TOSHIBA AMERICA CONSUMER PRODUCTS, INC.

## TECHNICAL BULLETIN

No. VCR9701

**Subject:** Audio upgrade.

Fig 1

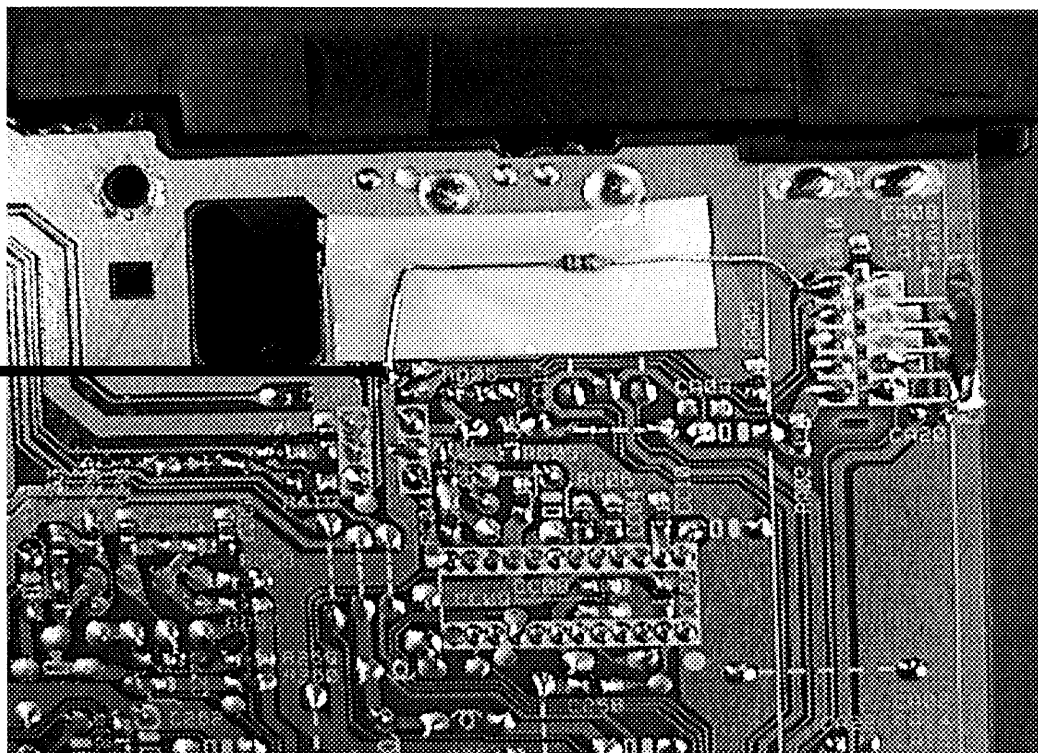
**Symptom:** Audio in E/E Mode is not as loud as in Direct Mode through the tuner.

**Corrective Action:** Place the above 220Ω resistor in parallel with RA01. (shown in Fig. 1 below)

Left side of  
RA01 (SMD)
